3B Containment Hydrodynamic Loads

The information in this appendix of the reference ABWR DCD, including all subsections, tables, and figures, is incorporated by reference with the following departures.

STD DEP 3B-2 (Table 3B-1, Figures 3B-12 and 3B-13)

Figure 3B-13 Schematic of the Pool Swell Phenomenon

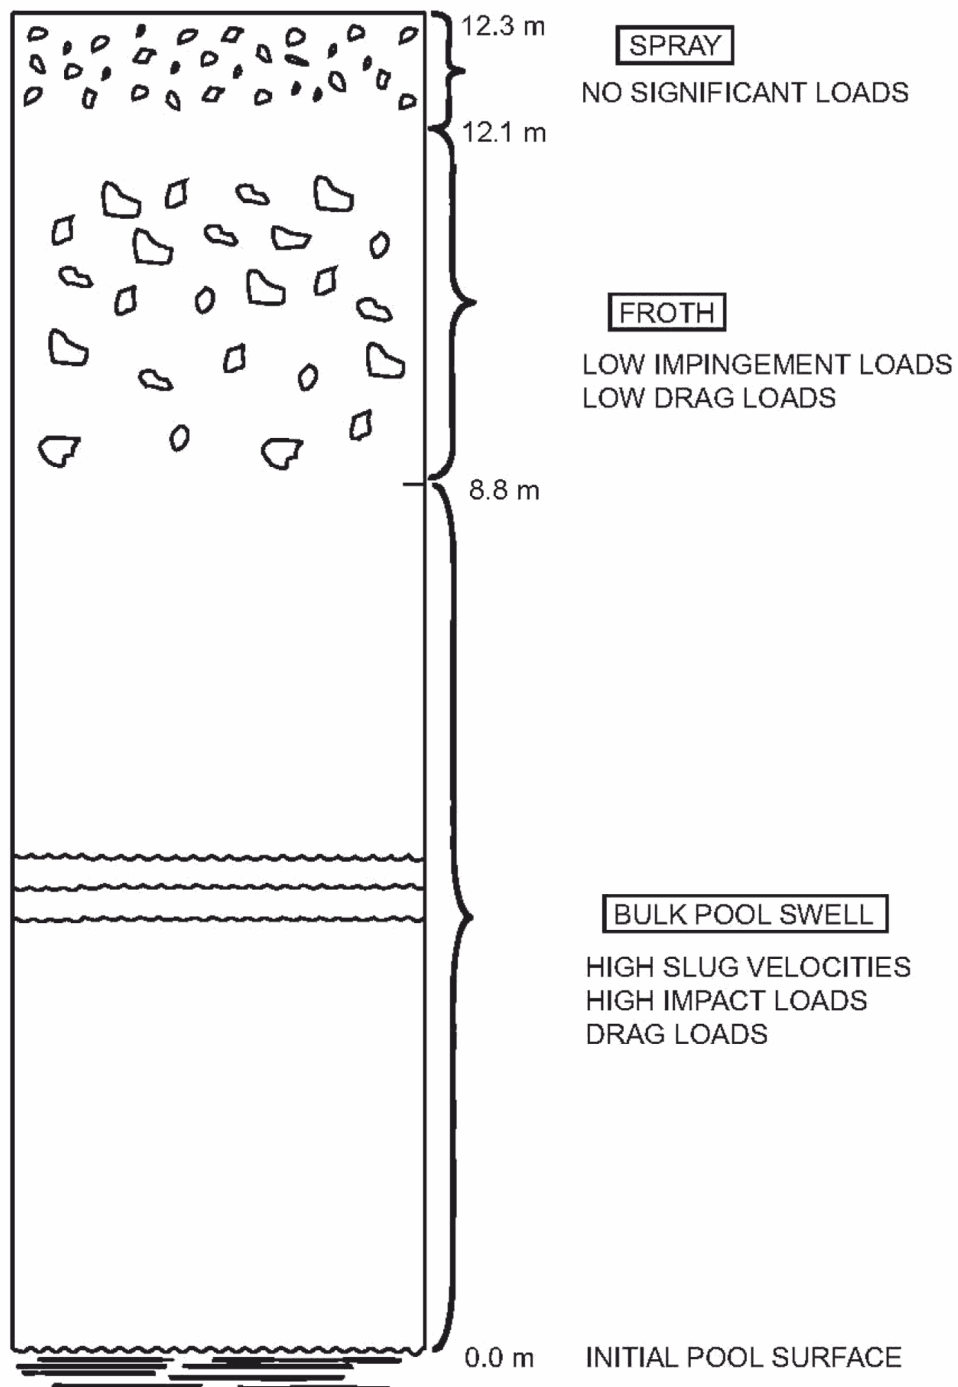
Structures located at elevations between the ~~7m~~8.8m and ~~40.3m~~12.1m will be subjected to froth impact loading. This is based on the assumption that bubble breakthrough (i.e., where the air bubbles penetrate the rising pool surface) occurs at ~~7m~~8.8m height, and the resulting froth swells to a height of 3.3m. ~~This froth swell height is the same as that defined for Mark III containment design and this.~~ This is considered to be conservative for the ABWR design. Because of substantially smaller wetwell gas space volume (about 1/5th of the Mark III design), the ABWR containment is expected to experience a froth swell height substantially lower than the Mark III design. The wetwell gas space is compressed by the rising liquid slug during pool swell, and the resulting increase in the wetwell gas space pressure will decelerate the liquid slug before the bubble break-through process begins. The load calculation methodology will be based on that approved for the Mark III containment (NUREG-0978).

As shown in Figure 3B-13 the gas space above the ~~40.3 m~~12.1m elevation will be exposed to spray condition ~~including~~ which is expected to induce no significant loads on structures in that region.

As drywell air flow through the horizontal vent system decreases and the air/water suppression pool mixture experiences gravity-induced phase separation, pool upward movement stops and the “fallback” process starts. During this process, structures between the bottom vent and the ~~40.3 m~~12.1m elevation can experience loads as the mixture of air and water fall past the structure. The load calculation methodology for ~~the~~ defining such loads will be based on that approved for Mark III containment (NUREG-0978).

Figure 3B-21 ABWR CO Source Load Methodology

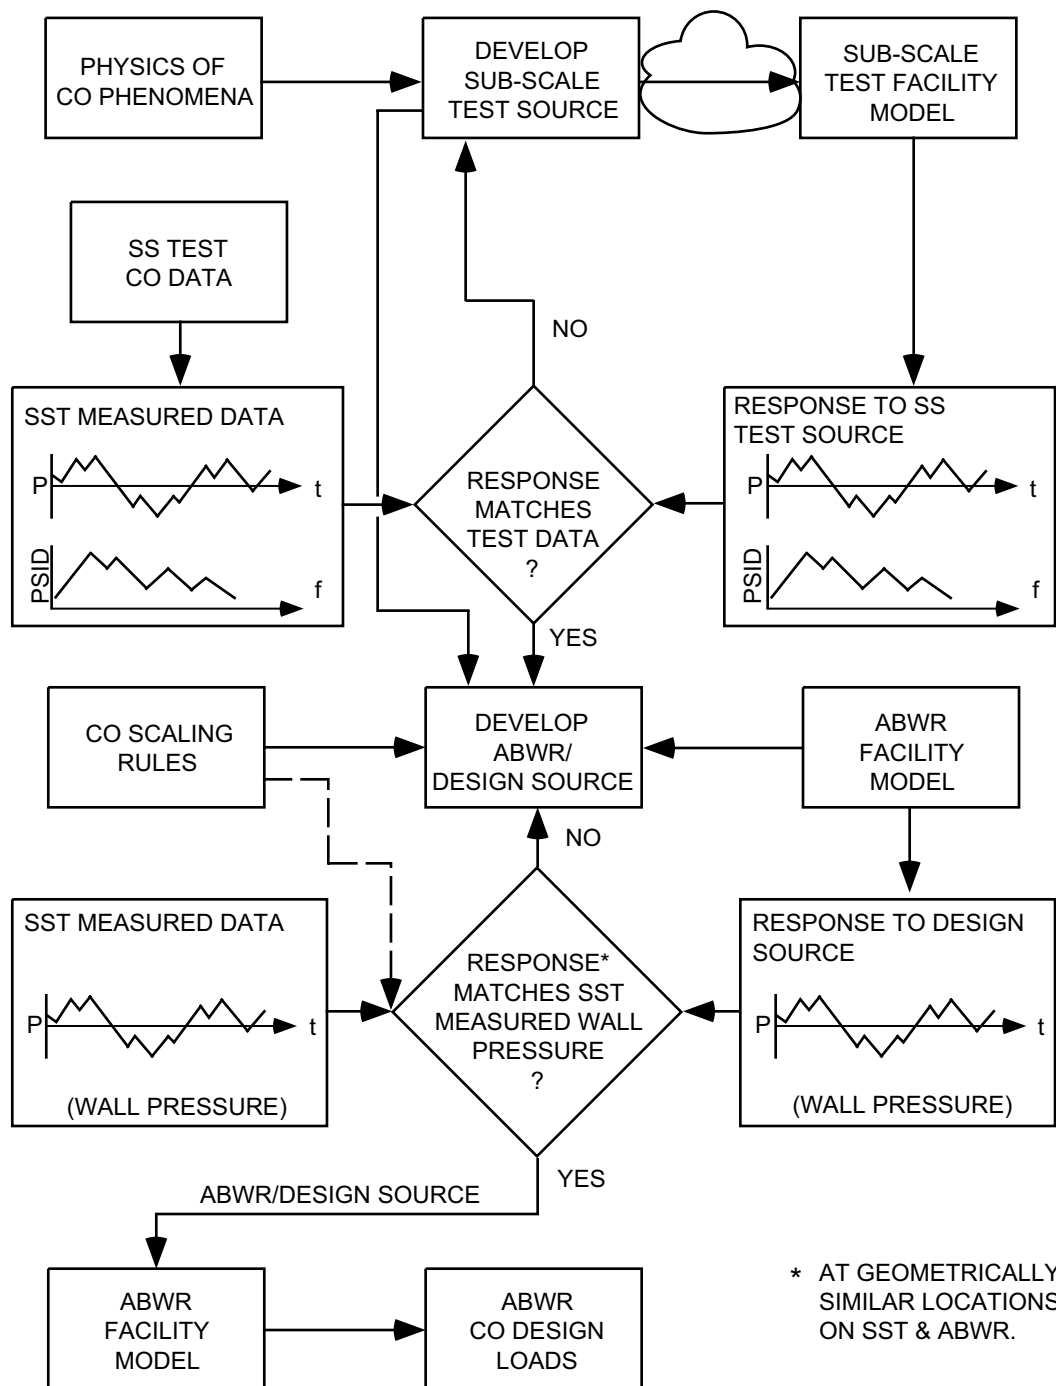
STD DEP Admin (Figures , 3B-21, 3B-24, 3B-26)
